Ministry of Public Works

Ref: 41-114-101 Paget Lights Rock Cut Remediation

This Addendum #1 contains (6) pages including this front page.

Figure 1 - Belco Markings from nearby pylon. Central dots indicate the expected cable path, but may fall within inner and outer boundaries which are also marked.

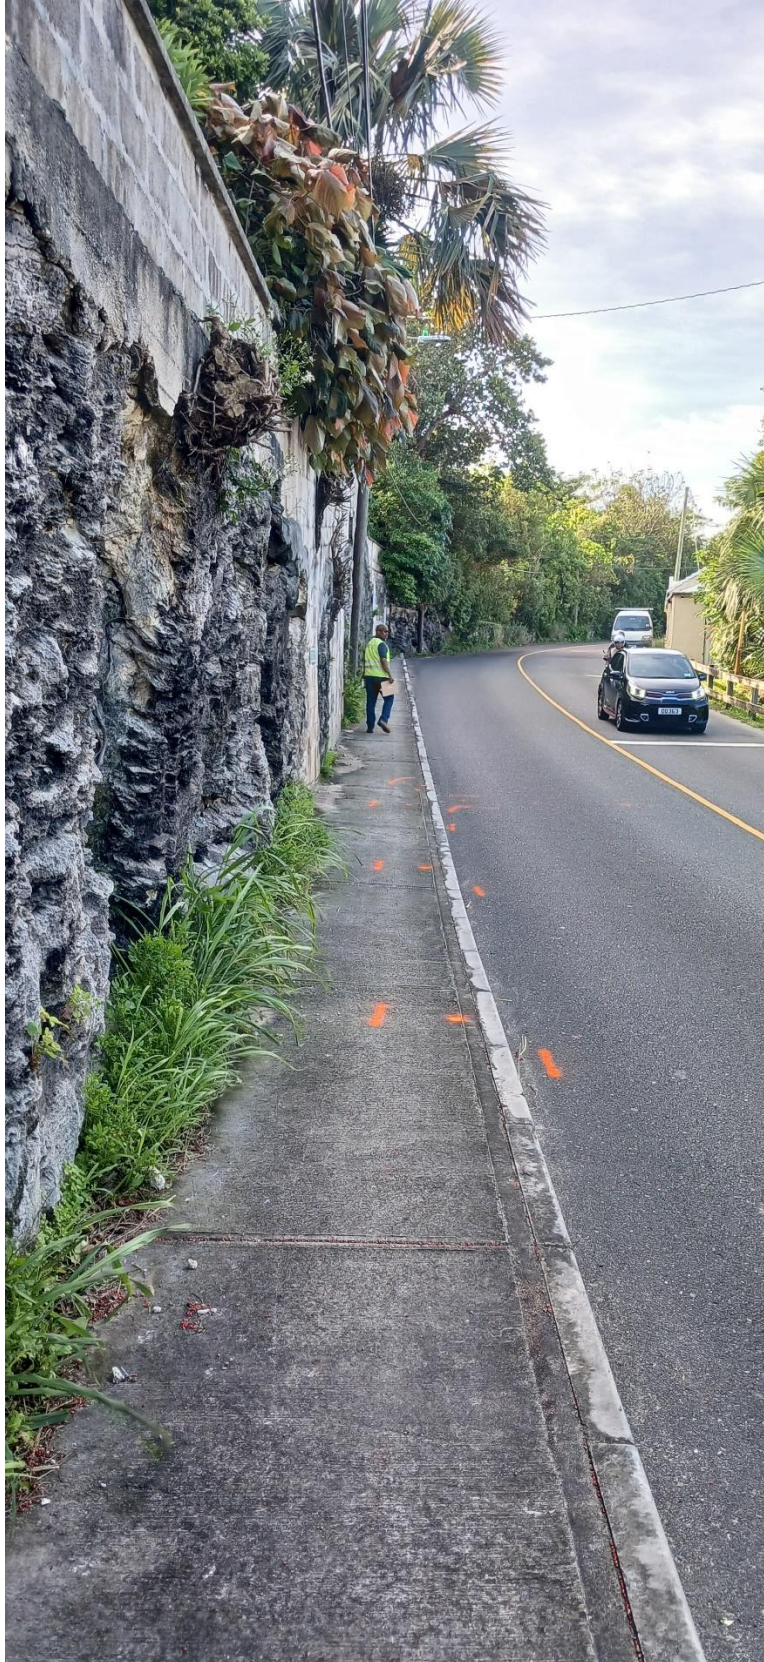
1. Q) What utilities are present under the sidewalk?

A) Belco visited site on the 29th of November 2023, and marked the expected path of the traffic light cables.

The cable travels under the sidewalk across the area where works are proposed, but is towards the roadside and is not expected to encroach on the wall footing. Regardless, the chosen contractor is to be mindful that live cabling is present when breakout works begin and care should be taken during excavation.
